Subject: RE: Copy of Distribution Letter + Plat for The Courtyards of Hyland Meadows AKA

VN-13 Phase 2 Final Plat

Here is the Map Room Review of the plat.

THE COURTYARDS OF HYLAND MEADOWS PHASE 2

3 of 3

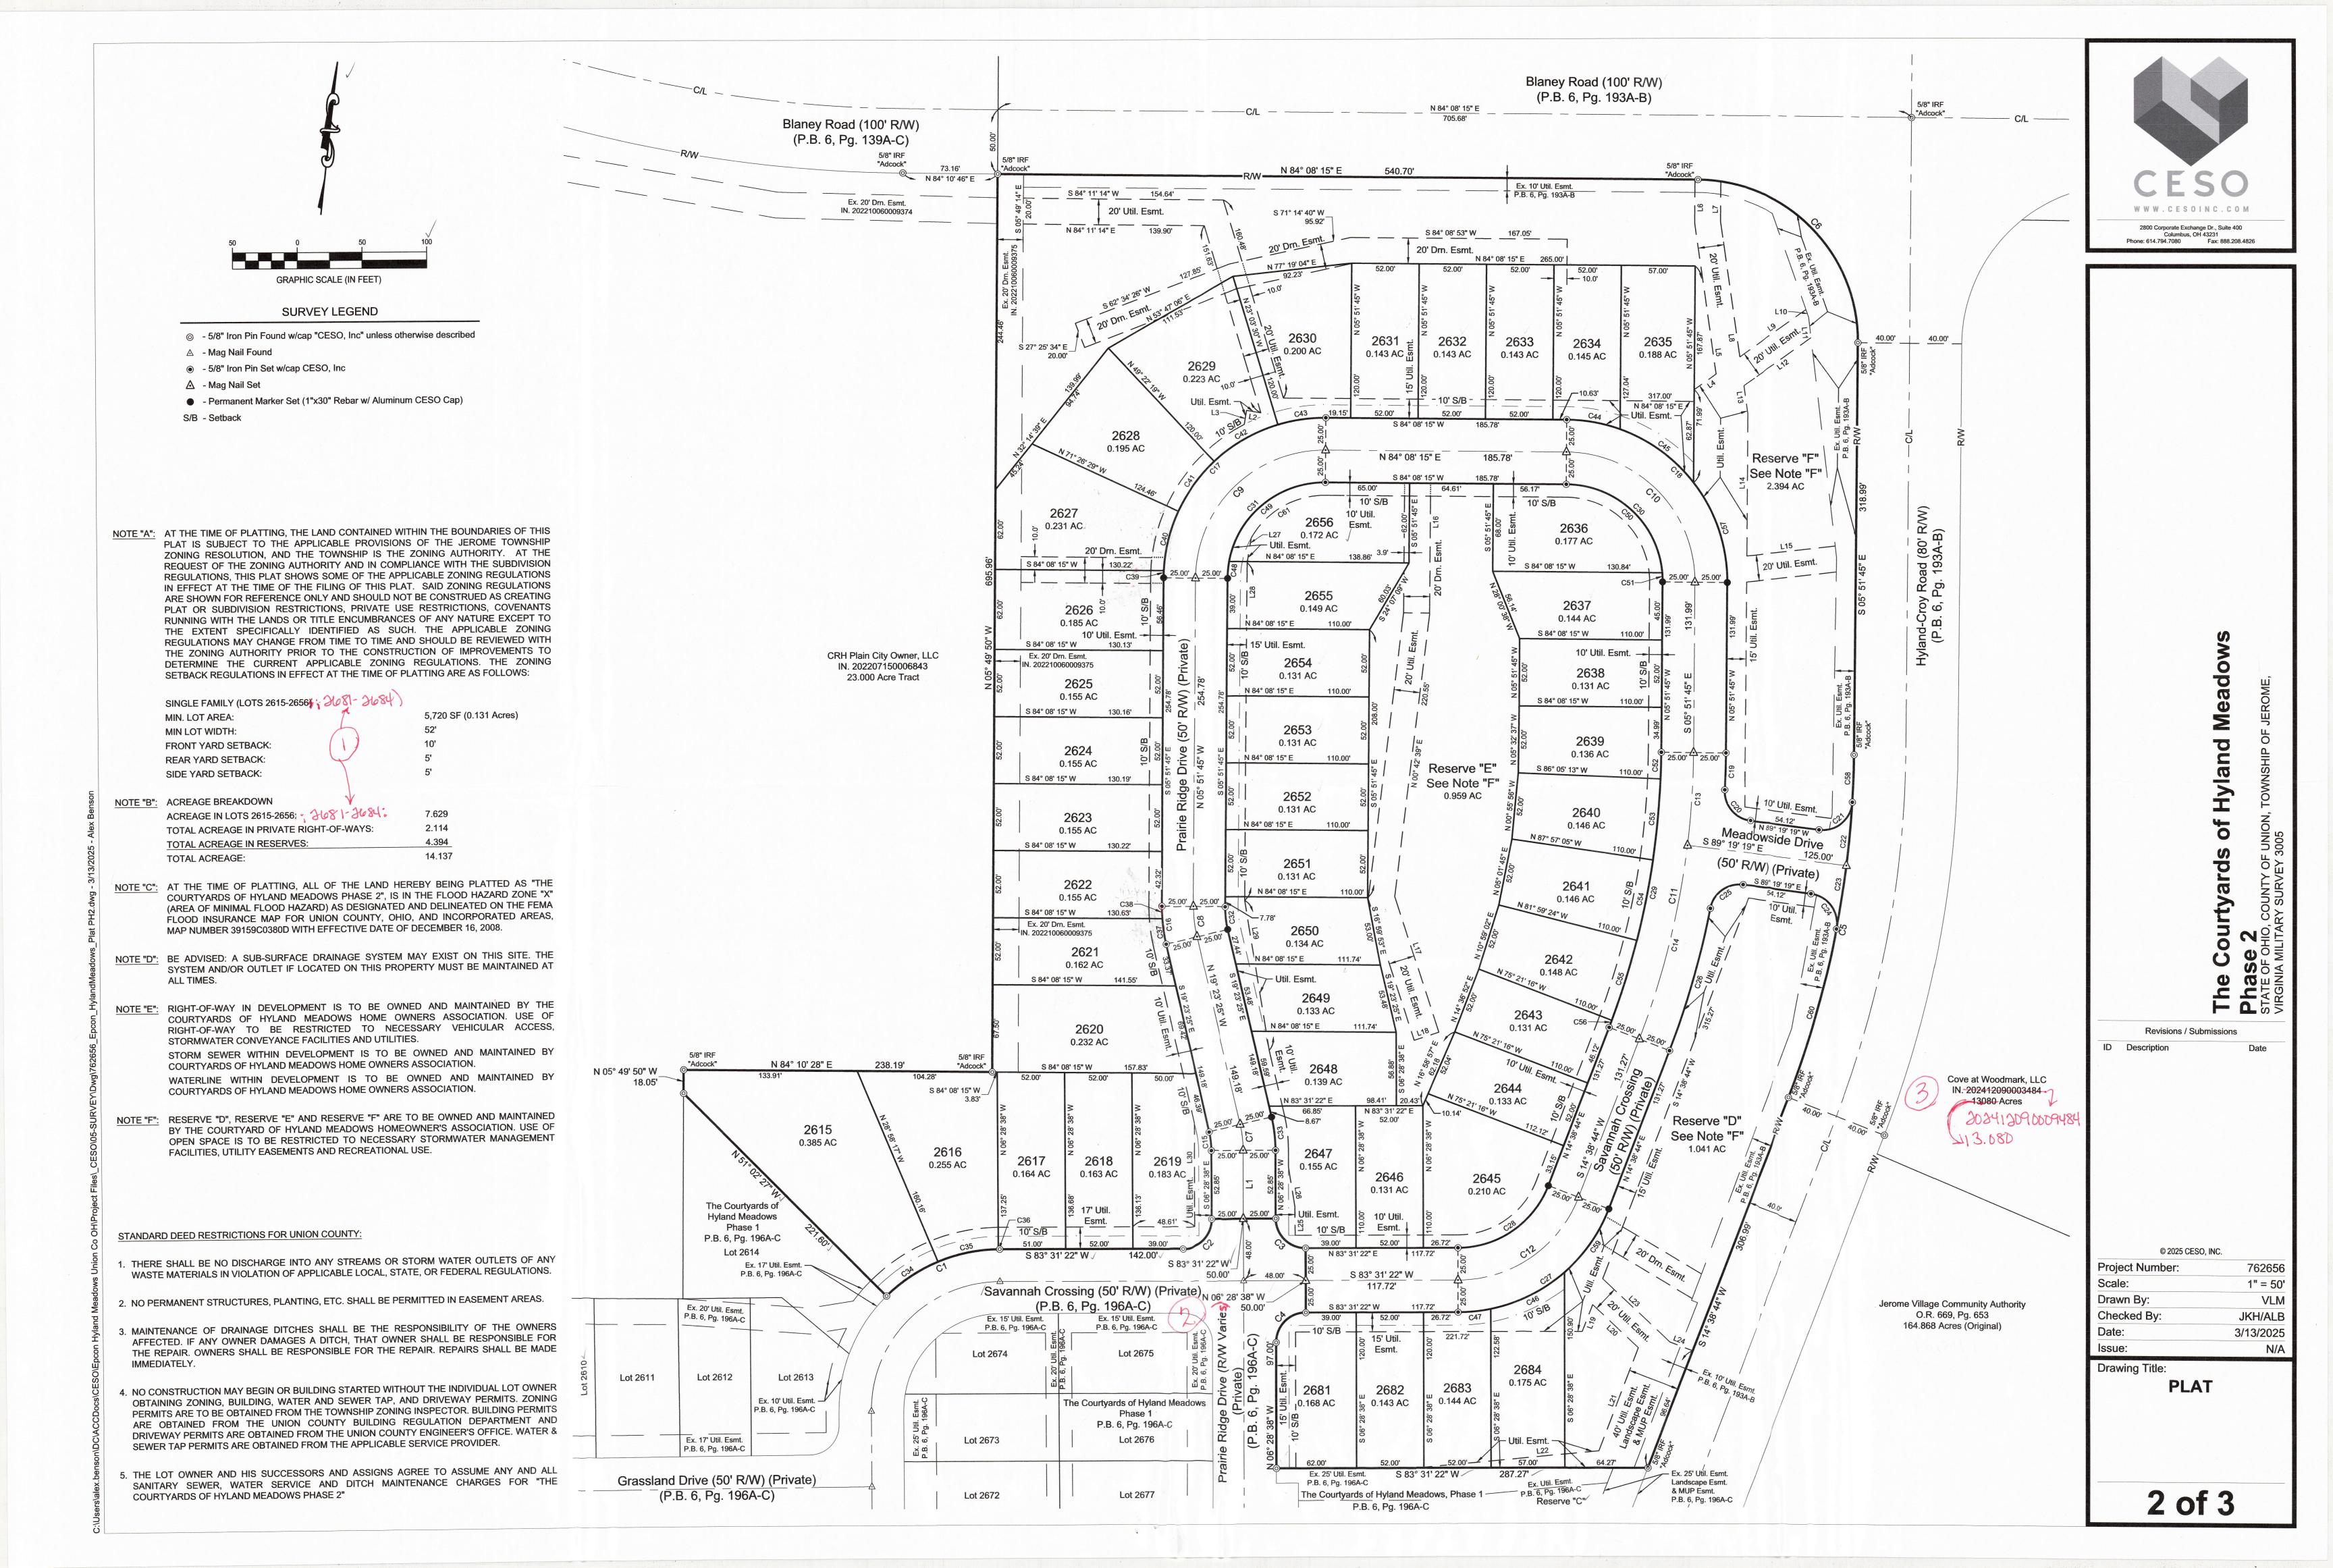
Page 3 Item 1 – Check the curve chord distances on Curve 37-40 in the curve table.
